Serial: RA-15-0050
January 19, 2016

Subject: Implementation of a Duke Energy Common Quality Assurance Topical Report

Duke Energy Carolinas, LLC, the licensee for the Catawba Nuclear Station, Unit Nos. 1 and 2, the McGuire Nuclear Station, Unit Nos. 1 and 2, the Oconee Nuclear Station, Unit Nos. 1, 2, and 3, and Duke Energy Progress, Inc, the licensee for the Shearon Harris Nuclear Power Plant, Unit No. 1, the Brunswick Steam Electric Plant, Unit Nos. 1 and 2, and the H. B. Robinson Steam Electric Plant, Unit No. 2 is submitting a common Quality Assurance Topical Report (QATR) in accordance with 10 CFR 50.54(a)(3). The Duke Energy QATR will be applied to 10 CFR 50 licensed activities. In addition, Duke Energy intends to apply the program to 10 CFR 71 and 10 CFR 72 activities in accordance with 10 CFR 71.101(f) and 10 CFR 72.140(d). Following plant-specific implementation, the Duke Energy QATR (Attachment 1) will replace the current Duke Energy Carolinas QATR and the site-specific quality assurance programs for the Shearon Harris Nuclear Power Plant, the Brunswick Steam Electric Plant, and the H. B. Robinson Steam Electric Plant. This letter satisfies the 10 CFR 50.54(a)(3) require

Figure 17-2. Corporate and Offsite Organization

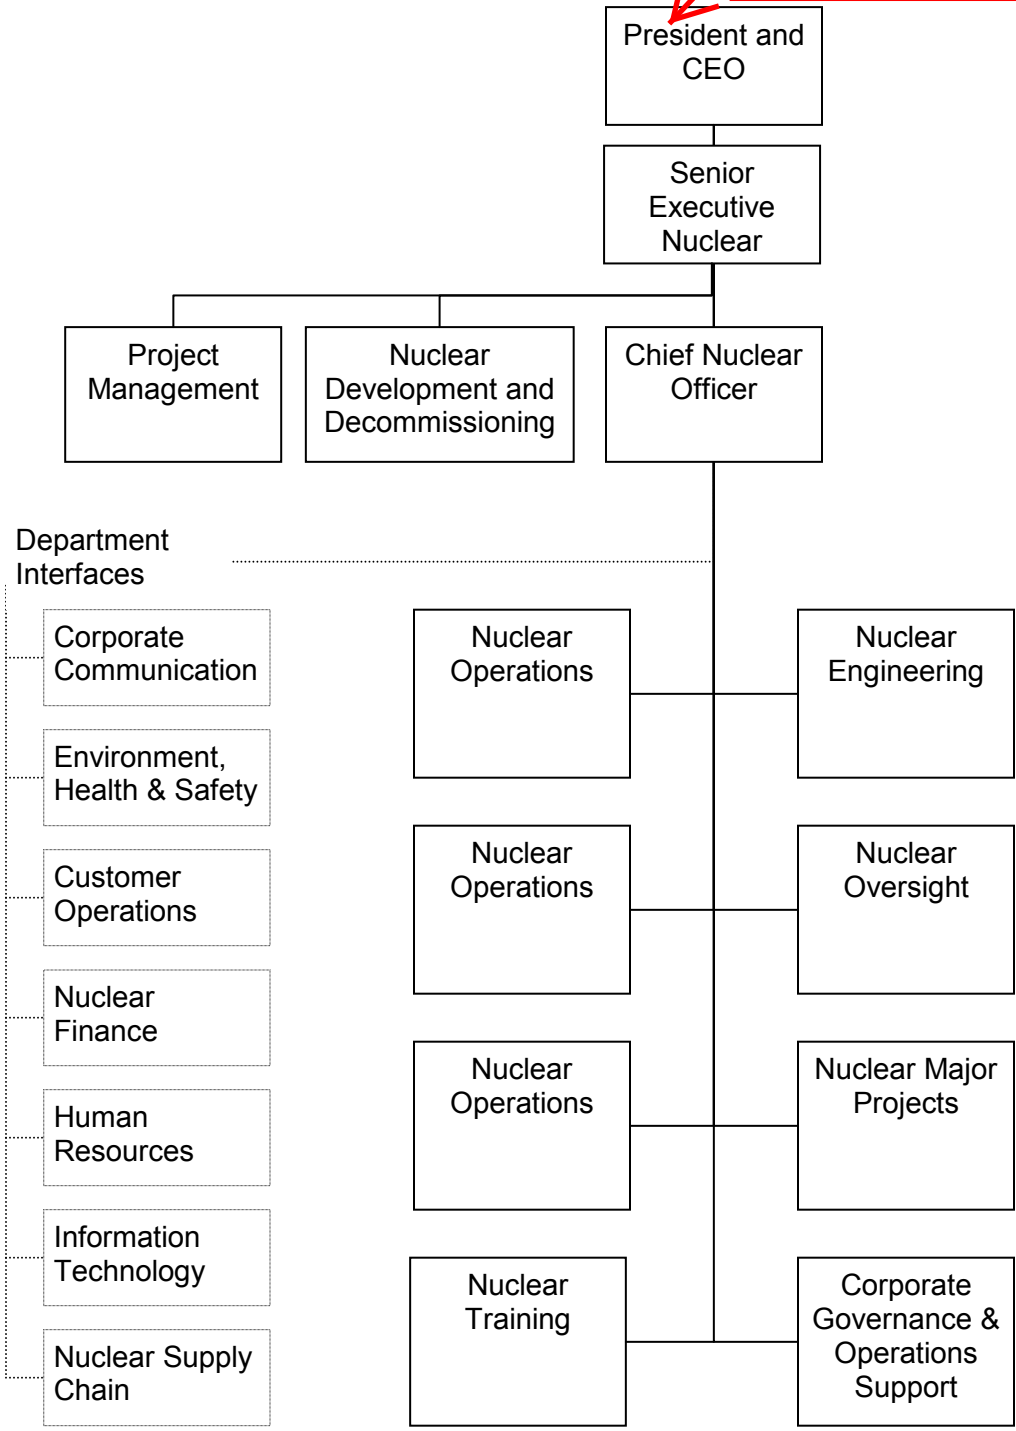
Figure 17-2 deleted.
